**PLANNING APPROVAL,
ZONING AMENDMENT
& SUBDIVISION STAFF REPORT****Date: July 21, 2016**

<u>APPLICANT NAME</u>	Central Presbyterian Church
<u>SUBDIVISION NAME</u>	Central Presbyterian Church Subdivision
<u>LOCATION</u>	1260 & 1262 Dauphin Street and 4 North Ann Street (Northeast corner of Dauphin Street and North Ann Street).
<u>CITY COUNCIL DISTRICT</u>	District 2
<u>PRESENT ZONING</u>	R-1, Single-Family Residential District, and B-1, Buffer Business District.
<u>PROPOSED ZONING</u>	B-1, Buffer Business District
<u>AREA OF PROPERTY</u>	1 Lot/2.1± Acres
<u>CONTEMPLATED USE</u>	<p>Subdivision approval to create a single legal lot of record from one metes-and-bounds parcel, and Zoning approval to rezone the site from R-1, Single-Family Residence District and B-1, Buffer Business District, to B-1, Buffer Business District.</p> <p>It should be noted, however, that any use permitted in the proposed district would be allowed at this location if the zoning is changed. Furthermore, the Planning Commission may consider zoning classifications other than that sought by the applicant for this property.</p>

SITE PLAN

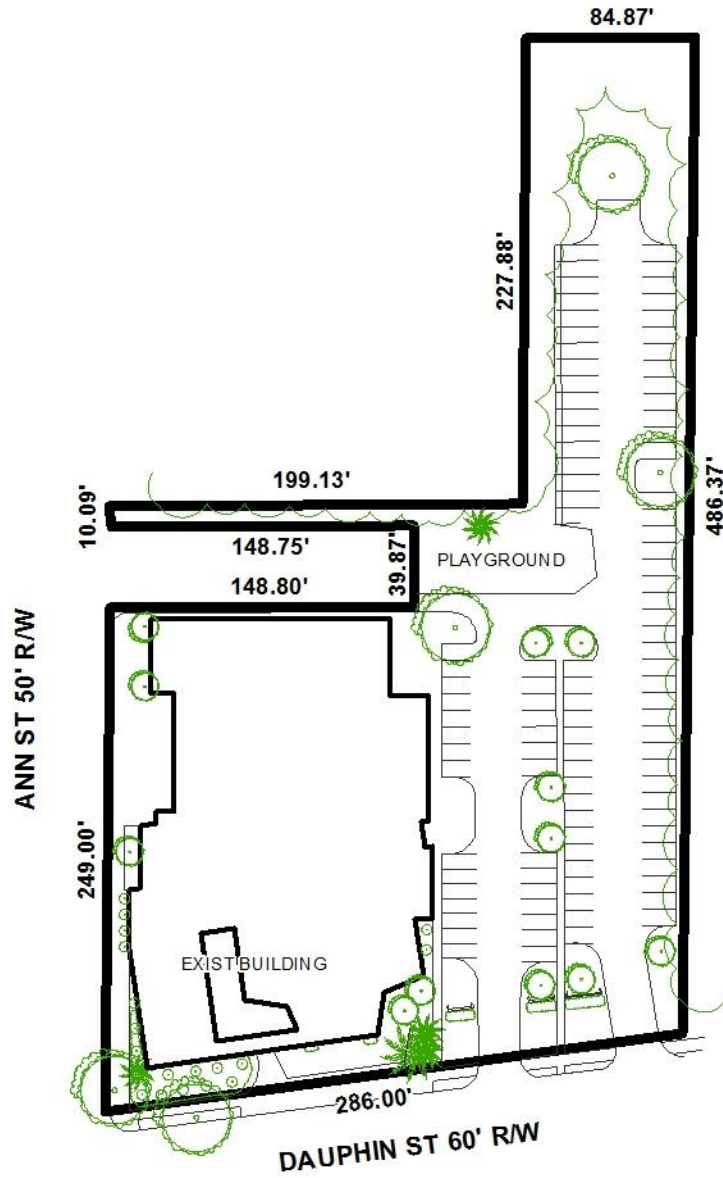
The site plan illustrates 102 existing, paved parking spaces, each of which appear to exceed the required length, but not the required width. Using recent aerial photos, Staff can determine that each parking stall meets the minimum width requirements for parking spaces, but some spaces are short 3'± in length. Presumably, the shorter parking stalls are delineated in such a way to ensure adequate aisle width for two-way traffic, a condition which appears to characterize maneuverability on the site. Using additional aerial photos, Staff can verify that such inadequacies in parking stall dimensions have existed since at least 1984; and, as such, may be considered non-conforming. However, revisions to the site plan should reflect existing parking stall dimensions for permitting, if approved.

The site plan does not illustrate any van accessible parking spaces, but photographs provided by the applicant indicate at least eight (8) accessible spaces which, again using aerial photographs have clearly existed since at least 2002 and may pre-date current accessible parking regulations. Revision of the site plan to illustrate existing accessible spaces should be required for permitting, if approved.

The site plan does not illustrate the provision of curbing or wheel stops, but Staff has determined using aerial photographs, as well as photographs provided by the applicant, that all 102 parking spaces are provided with wheel stops where vehicles could extend beyond the parking facility. As such, all existing wheel stops should be illustrated on a revised site plan for permitting, if approved.

The site plan illustrates existing trees and indicates existing landscape calculations; however, aerial photographs suggest that the site is not in compliance with current landscaping and tree regulations and that the provided landscaping calculations appear to be incorrect. Given there are no proposed exterior improvements to the site, such compliance is not required; but, if the current application is approved, revisions to the site plan indicating the correct landscaping calculations should be required for permitting.

A dumpster is not illustrated on the site plan, and one is not visible in recent aerial photographs. If a dumpster will be placed on the property, it must comply with the current dumpster enclosure and sanitary sewer connection requirements of Section 64-4.D.9. of the Zoning Ordinance; or, the applicant may place a note on the site plan stating curbside waste removal will be utilized, if approved.

Photographs provided by the applicant show an existing, exterior playground; thus, a protection buffer is required per Chapter 64-4. D.1. of the Zoning Ordinance where the playground abuts residential property. Revision of the site plan to illustrate such a buffer in the form of a wall, wooden privacy fence, or the inclusion of a screen planting strip will be required for permitting, if approved.

It should be noted that the current site plan indicates there are 104 parking spaces; however, 102 parking spaces are illustrated. This information should be corrected on a revised site plan, if approved.

- 1) revision of the site plan to accurately depict existing parking stall dimensions;*
- 2) revision of the site plan to indicate existing accessible parking spaces;*

- 3) *revision of the site plan to illustrate existing wheel stops for parking spaces;*
- 4) *revision of the site plan to accurately indicate existing landscaping;*

- 5) *revision of the site plan to provide a dumpster, if one will be utilized, in compliance with the current enclosure and sanitary sewer connection requirements of Section 64-4.D.9. of the Zoning Ordinance, or placement of a note on the site plan stating that curbside pickup will be utilized;*

- 6) *revision of the site plan to illustrate an appropriate protection buffer in the form of a wall, wooden privacy fence, or the inclusion of a screen planting strip where the existing playground abuts residentially-developed properties ;*

- 7) *correction of the site plan to indicate the site is equipped with 102 parking stalls;*
- 8) *attainment of all necessary permits prior to the issuance of Zoning Clearance;*

DETAIL SITE PLAN

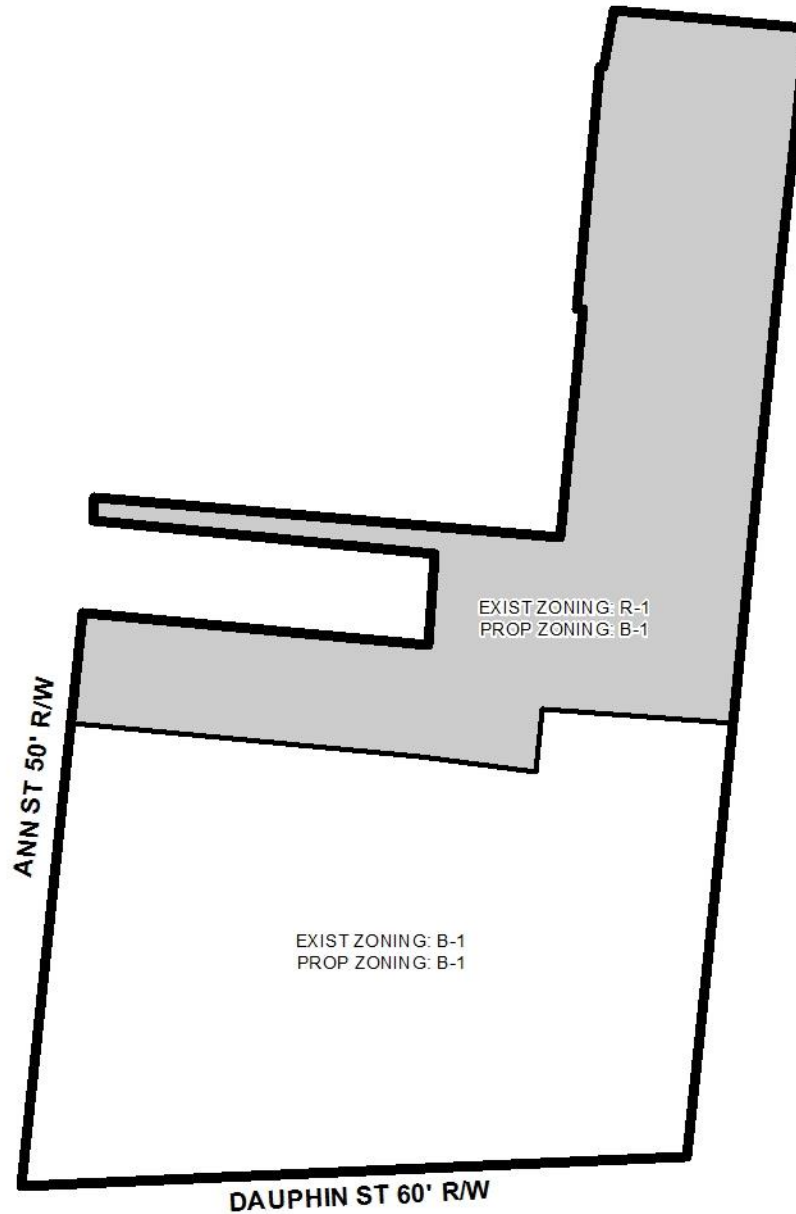
The preliminary plat illustrates the proposed 1-lot, 2.1± acres subdivision located on the Northeast corner of Dauphin Street and North Ann Street.

The site has frontage on Dauphin Street, a major street requiring a 100' right-of-way, and North Ann Street, a minor street with curb and gutter requiring a 50' right-of-way. An adequate 50' right-of-way width along North Ann Street is depicted, therefore making no dedication necessary; and the preliminary plat illustrates a 60' right-of-way width along Dauphin Street, thus normally requiring revision of the plat to dedicate 50' from the centerline of Dauphin Street. However, if dedication were required, it would result in a portion of the existing structure being situated in the right-of-way; therefore, a waiver of Section V.D.9. of the Subdivision Regulations would be required to allow just a 25' setback from the existing Dauphin Street right-of-way. Considering a waiver of Section V.D.9. of the Subdivision Regulations was granted by the Planning Commission at its July 7, 2016 meeting for a similar situation at a proximal site, such a waiver may also be appropriate for the subject site.

Dedication of the corner radii at Dauphin Street and North Ann Street should be required per Section V.D.6. of the Subdivision Regulations.

It should be noted that the 25' minimum building setback line is not illustrated along all street frontages where the lot is at least 60' wide; however, Side and Rear Yard Setback variances were granted by the Board of Zoning Adjustment at its May 02, 1952 meeting, followed by a 6-month extension at its November 13, 1953 meeting. Additionally, at its November 6, 1962 meeting, the Board approved Front and Side Yard setback variances. Nevertheless, the 25' minimum building setback line should be illustrated along North Ann Street where the lot is at least 60' wide, per Section V.D.9. of the Subdivision Regulations.

It should be noted that the lot is irregular in shape and may be considered a flag lot, a design which is generally discouraged by Section V.D.1. of the Subdivision Regulations. However, similar lots are permitted in locations where varied and irregularly-shaped lot designs are common and the informality of design is consistent with other lots in the vicinity. The subject lot is seemingly the result of the purchasing of various standard lots over the years, the combination of which has resulted in an irregular shape. While the Subdivision Regulations discourage such irregularities in subdivision design, the site was developed well before current regulations and, as such, may be appropriate. Additionally, at least two lots whose designs may also be considered flag lots and were approved by the Planning Commission are located within 850' of the site; and, as such, waiver of Section V.D.1. of the Subdivision Regulations may be appropriate.

With regards to access management a portion of the site has 10' of frontage along North Ann Street resulting from the lot's irregular shape, and may facilitate an opened alley. However, 10' is an inadequate width to provide vehicle access to the lot from this portion of the site and, as such, should be prohibited from doing so until additional street frontage is provided. Until such a time when additional street frontage can be provided along North Ann Street, the lot should be limited to its existing curb cuts along Dauphin Street, with any changes in their sizes, locations or designs to be approved by Traffic Engineering, and conform to AASHTO standards. A note stating as much should be provided on the Final Plat, if approved.

- 1) *dedication of the corner radii per Section V.D.6. of the Subdivision Regulations;*
- 2) *retention of the lot size in square feet and acres on the Final Plat, or the furnishing of a table on the Final Plat providing the same information, adjusted for any right-of-way dedication;*

- 3) *revision of the Final Plat to illustrate the 25' minimum building setback line along all frontages where the lot is at least 60' in width;*
- 4) *placement of a note on the Final Plat stating that, until such a time when additional street frontage can be provided along North Ann Street, the lot should be limited to its existing curb cuts along Dauphin Street, with any changes in their sizes, locations or designs to be approved by Traffic Engineering, and conform to AASHTO standards;*
